B2024-TH-01

ADDENDUM #3 -

SEABROOK TOWN OFFICE BOILER REPLACEMENT C ONTRACTOR QUESTIONS & COMMENTS

SEABROOK TOWN OFFICE BOILER REPLACEMENT SCOPE OF WORK

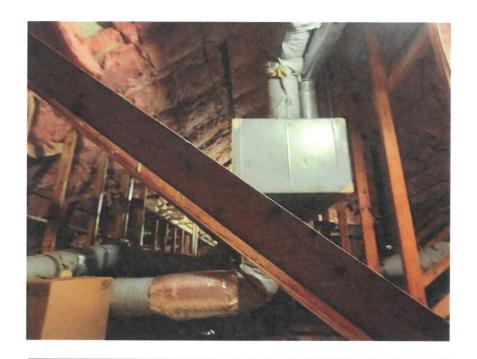
- 1. Is there glycol in the system?
 - a. A small amount of water was drained from the system. Based on the color there is <u>no</u> glycol in the system. The air handlers are in attic space. In approximately 2007 Spray foam was applied to the interior of the walls and to the underside of the roof. There are also fiberglass batts in the roof. See attached photo pages.
